For your information, defects as below found on a number of mini Miami rides , manufacture ; danum uk / f stokes.

1) general overview of device.

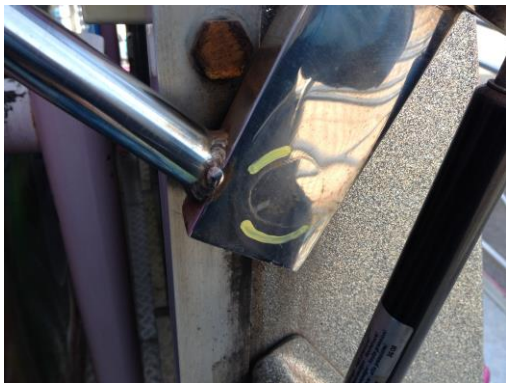
locator peg.

2) weld/ material defect found on lap bar lock

3) weld defect lap bar control arm right hand side, protective padding is required to be partially removed for access.

4) weld/ material defect, lap bar left hand side control arm, outside (connection between control peg & stainless box section).

After speaking with the controller & witnessing operation of the device, it appears the lap bar is release via the control pedal & electric switch situated on the left hand side of the gondola , the opening / closing procedure I believe is contributing to the twist and uneven locking due to the length of the lap bar & containment issue which prevents opening / closing from the central position, I have advised the controller to visually monitor the area as part of the weekly inspections, and report any further defects.
